PCN#: Q2092401

## **DESIGN/PROCESS CHANGE NOTIFICATION -- FINAL**

Change Type Description: Alternate Assembly/Test Location/Qualification, Assembly Process, Lead Finish Composition, Package External Dimension

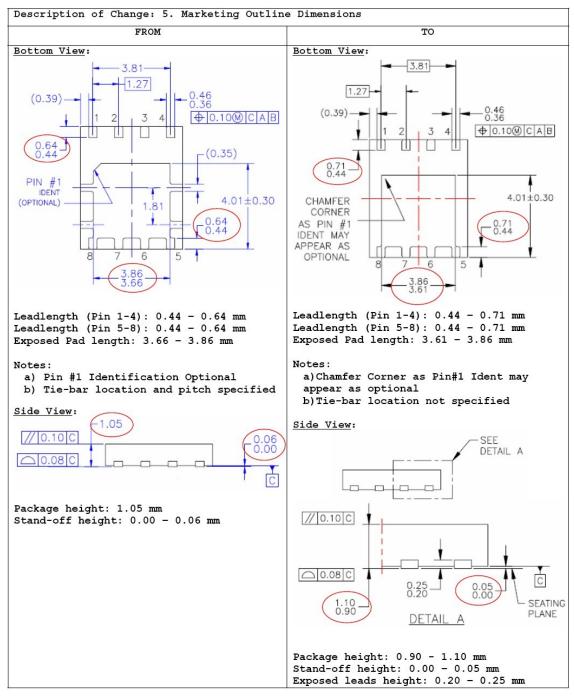
Description of Change (From): Selected MOSFET products currently assembled in Power 56 package at Fairchild Semiconductor in Cebu, Philippines. Current singulation method is Saw Singulation; current plating finish is NiPdAu; and current Die Attach Pad & Leadpost plating is NiPdAu. To view "From/To" Marketing Outline Dimensions, please refer to the attached table "Marketing Outline Dimensions."

Description of Change (To): Selected MOSFET products assembled in Power 56 package will also be assembled at GEM Shanghai, China. The alternate singulation method will be Punched Singulation; alternate plating finish will be Pure Sn; and alternate Die Attach Pad & Leadpost plating will be Bare Cu.

## Change From

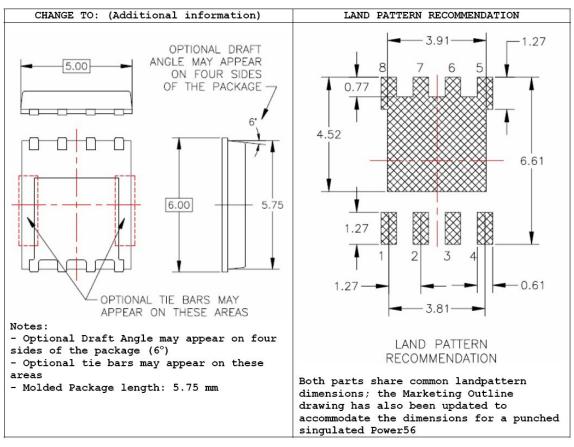
Reason for Change: Fairchild Semiconductor intends to qualify GEM Shanghai as an alternate assembly site for Power 56 package to support volume ramp. The Marketing Outline drawing has been updated to accommodate the dimensions for a punched singulated Power56, as illustrated in the table. There will be no change on the Part number as both parts share common landpattern dimensions and thus should be interchangeable from their end. The reference landpattern drawing is shown for reference. Fairchild Semiconductor's selected MOSFET devices assembled in Power 56 package will be affected by this change.
